Subject: Transmittal of Class 1 Permit Modification Request to Remove Structures from the Los Alamos National Laboratory (LANL) Hazardous Waste Facility Permit, EPA ID No. NM0890010515

**Class 1 Permit Modification Request for Removal of Three
Structures (RTR1, RTR2, and MCS HENC) from Technical
Area 54**

EPC-DO-16-198

Figure G.11-1: Technical Area 54, Area G, Pad 10 Outdoor Container Storage Unit Grid Sampling and Additional Sampling Locations

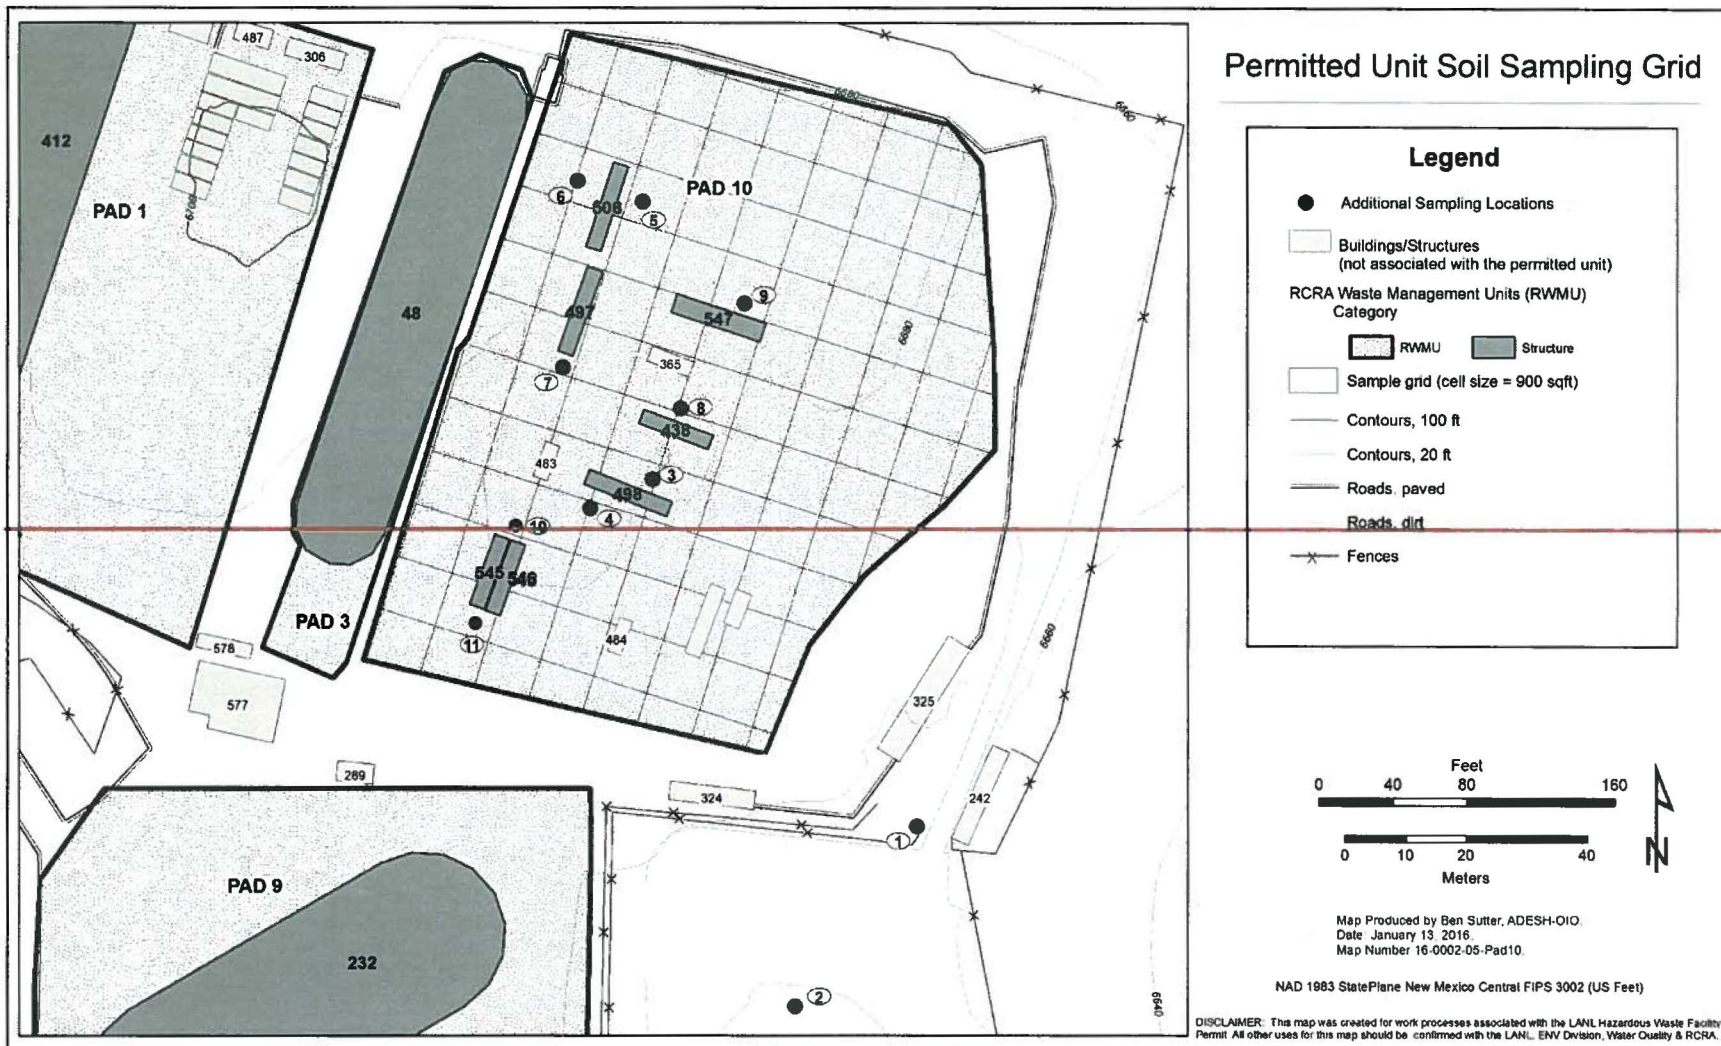
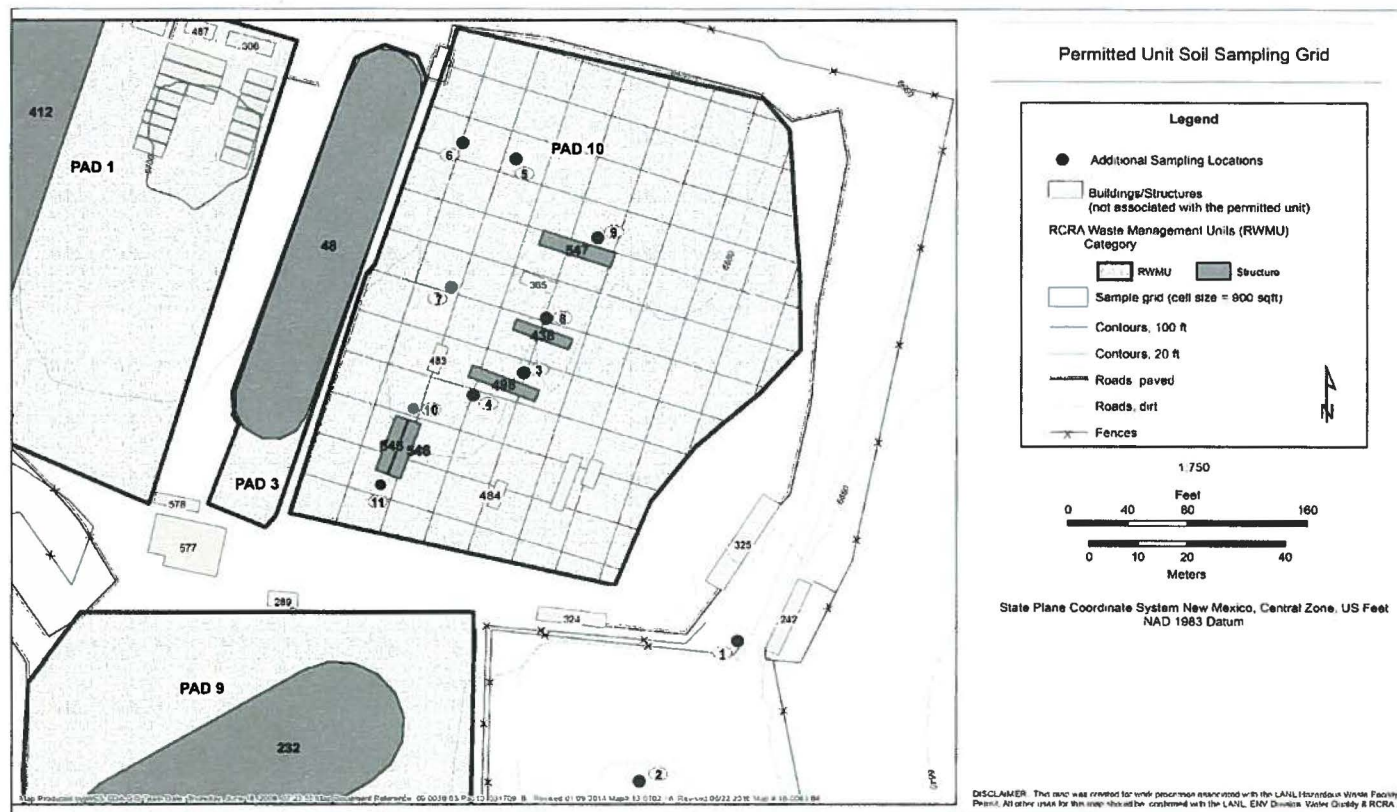
Attachment G.11, *Technical Area 54, Area G, Pad 10 Outdoor Container Storage Unit Closure Plan*, proposed revision reflects removal of the RTR2 (TA-54-0497) and MCS HENC (TA-54-0506) structures from the description of unit to be closed. A statement has been added to Section 2.0 noting the removal of the RTR2 and MCS HENC non-intrusive waste characterization structures in 2016. Figure G.11-1 *Technical Area 54, Area G, Pad 10 Outdoor Container Storage Unit Sampling Grid and Additional Sampling Locations* proposed revision reflects removal of the RTR2 and MCS HENC structures, however, the unloading area sample locations remain as required sample locations for execution of the G.11 closure plan.

Figure G.12-1: Technical Area 54, Area G, Pad 11 Outdoor Container Storage Unit Grid Sampling and Additional Sampling Locations

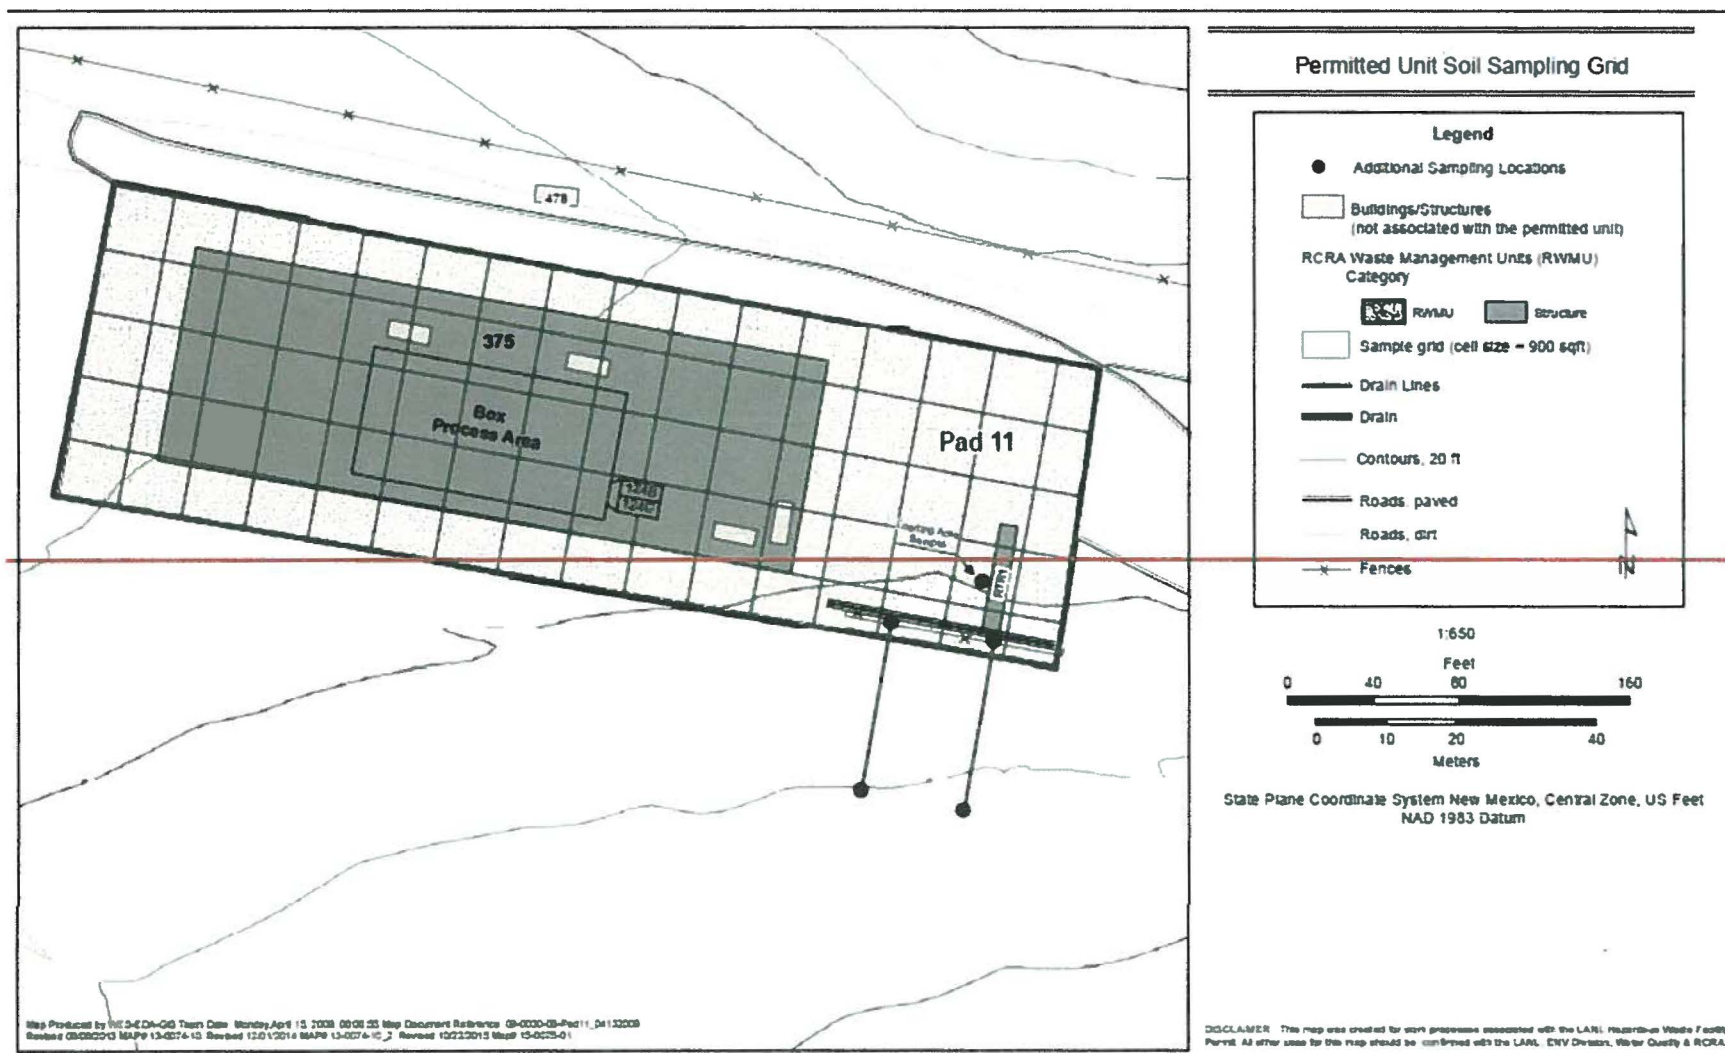
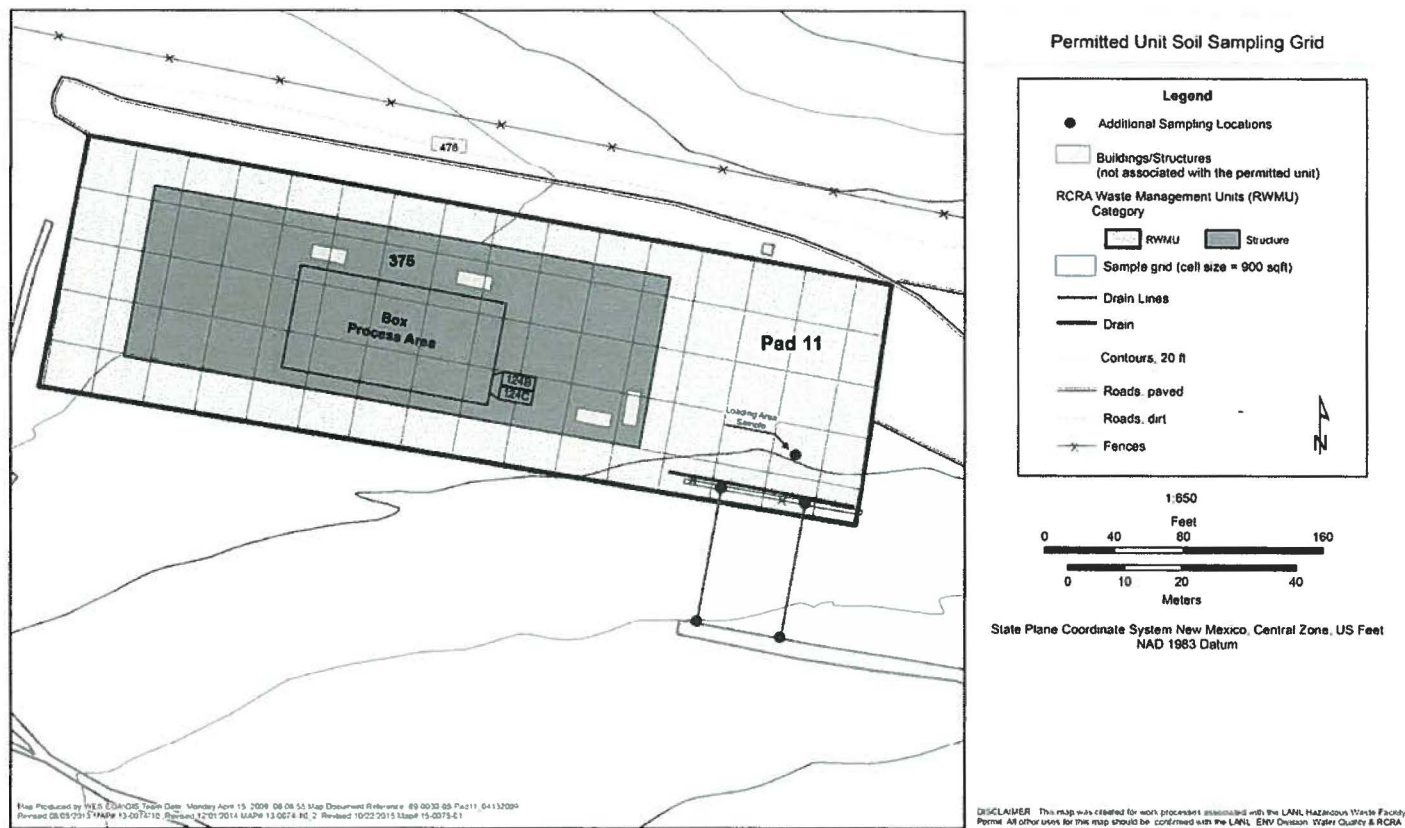
Attachment G.12, *Technical Area 54, Area G, Pad 11 Outdoor Container Storage Unit Closure Plan*, proposed revision reflects removal of the RTR1 (TA-54-0362) modular characterization equipment trailer (e.g., structure) from the description of unit to be closed. A statement has been added to Section 2.0 noting the removal of the RTR2 and MCS HENC non-intrusive waste characterization structures in 2016. Figure G.12-1 *Technical Area 54, Area G, Pad 11 Outdoor Container Storage Unit Sampling Grid and Additional Sampling Locations* proposed revision reflects removal of the RTR1 structure, however, the existing unloading area sample locations remain, as required, as sample locations for execution of the G.12 closure plan. In addition, table call outs in Attachment G.12, Sections 5.3.2 and 6.4.2.1 were incorrectly labeled as Tables G.12-8 and G.12-7 and have been corrected to Tables G.12-6 and G.12-5, respectively. Track change format copies of both revised pages are provided.

Figure 27: Technical Area 54, Area G, Container Storage Units

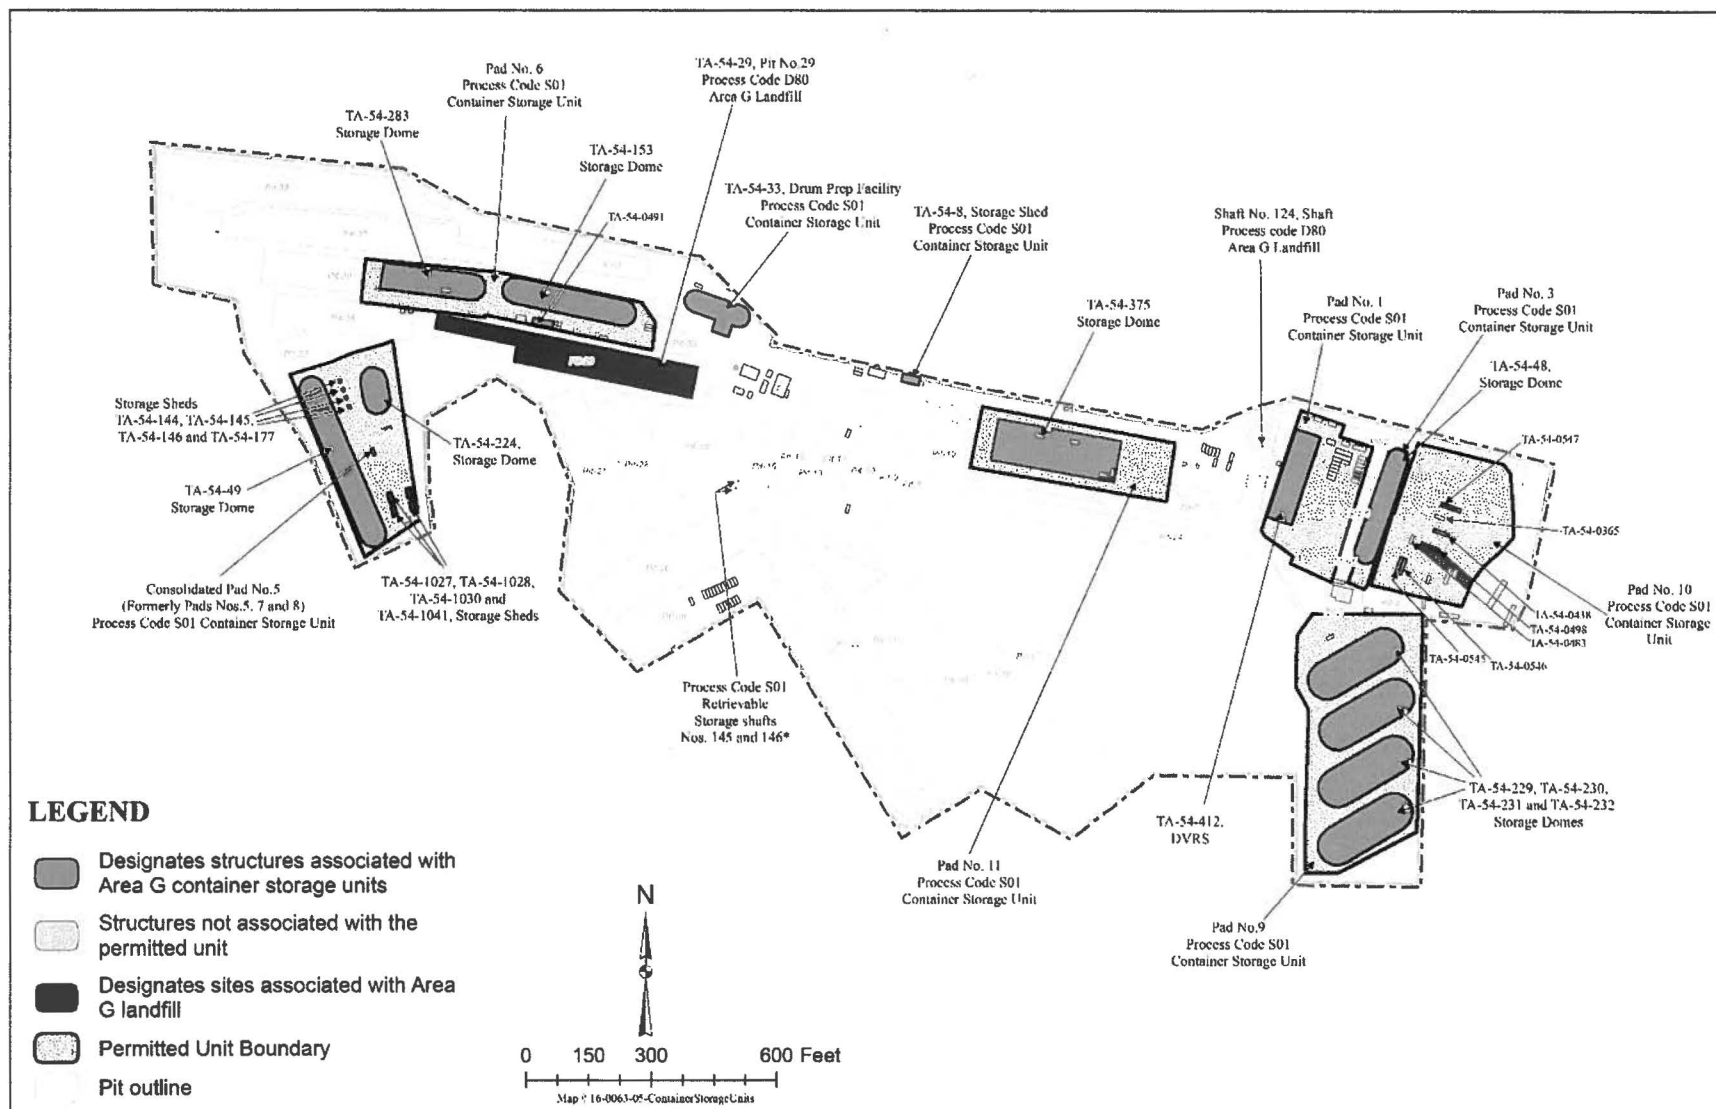
Attachment N, *Figures*, reflects the proposed removal of the three structures from Figures 27, 31 and 36. Figure 27, *Technical Area 54, Area G, Container Storage Units*, revision reflects the proposed removal of two structures (TA-54-0497 and TA-54-0506) from Pad 10, and the proposed removal of a single structure from Pad 11 (TA-54-0360). Figure 27 revisions also reflect the removal of structure TA-54-1059. The removal of TA-54-1059 was approved by NMED for re-location from TA-54 Pad 10 to TA-54 Pad 1 on May 18, 2016 in acceptance of Permit Modification Notification EPC-DO-16-056/LA-UR-16-21078.
